Findings of Fact | Wetland Conditional Use Permit

City of Portsmouth Planning Board

Application #: LU-23-157

RE: 0 Springbrook Circle, LU-23-157

C2

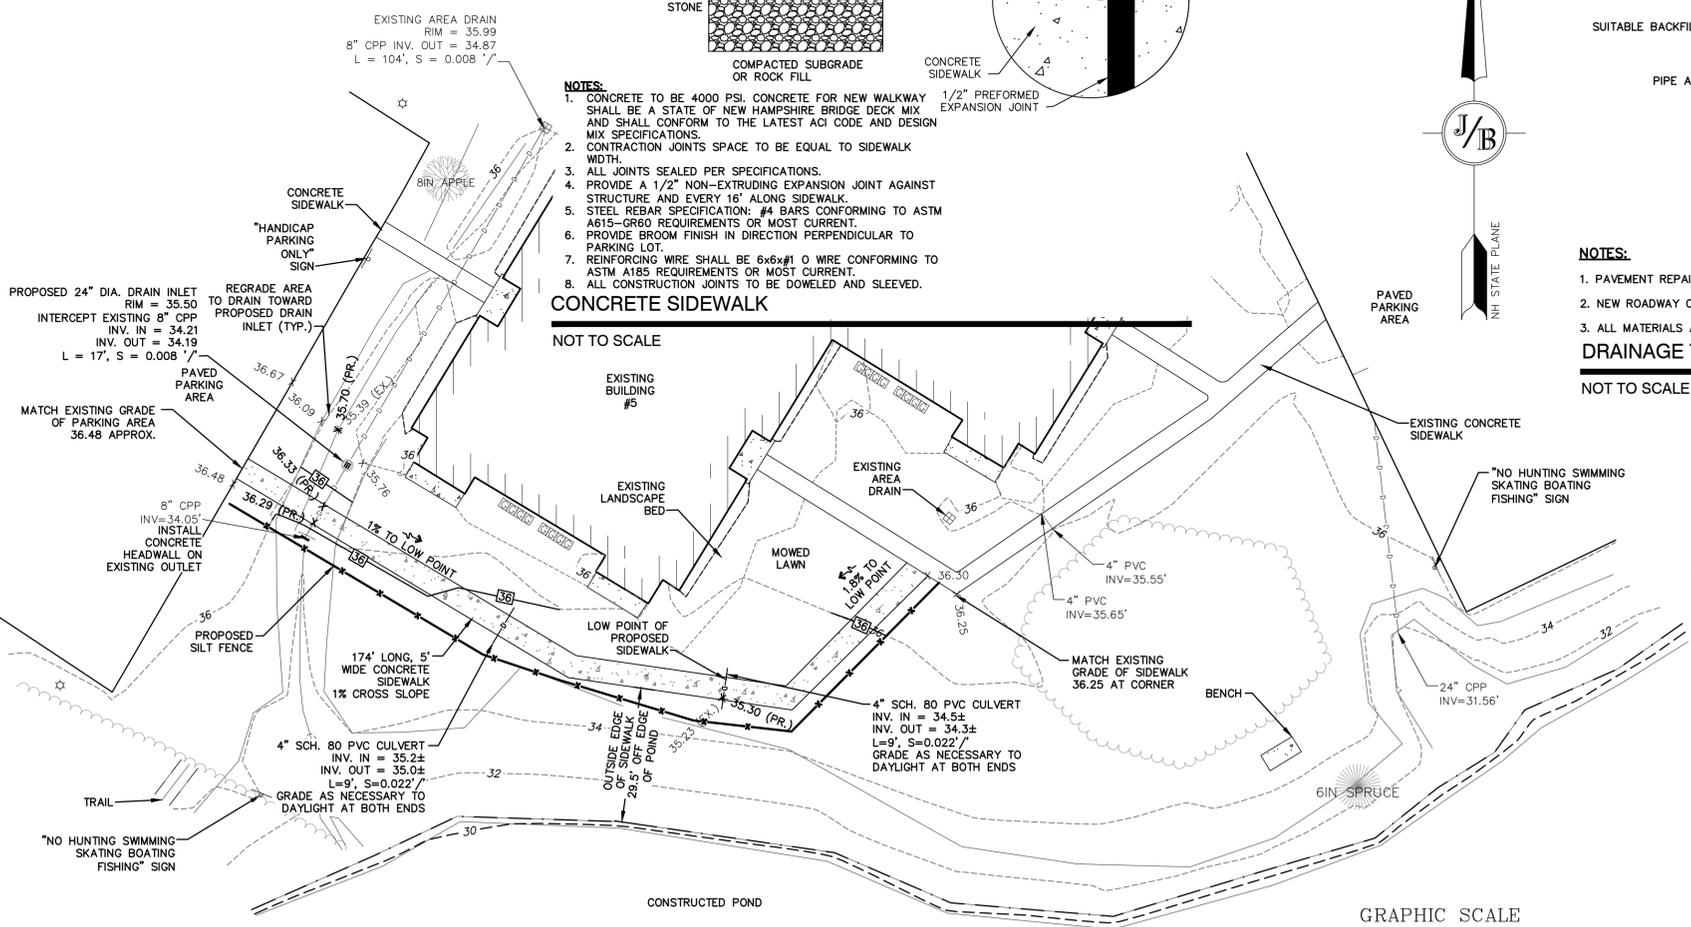
The proposed sidewalk shall be moved from where it is proposed to connect on the eastern end, to instead connect approximately 8 ft. closer to Building #5 to reduce sidewalk length and proximity to the pond.

The sidewalk shall be, at a maximum, 5 ft. wide.

The proposed silt fence shall be extended to encompass the entire length of the sidewalk project.

The revised Sidewalk Construction Plan, Dwg. # C2, Prepared by Jones & Beach Engineers, Inc., Dated 10/19/22, Revised 10/23/2023, has incorporated this change.

To ensure compliance with existing requirements, the revised Sidewalk Construction Plan, Dwg. # C2, Prepared by Jones & Beach Engineers, Inc., Dated 10/19/22, Revised 10/23/2023, identifies the walkway width as being 5'.

The revised Sidewalk Construction Plan, Dwg. # C2, Prepared by Jones & Beach Engineers, Inc., Dated 10/19/22, Revised 10/23/2023, has incorporated this change.
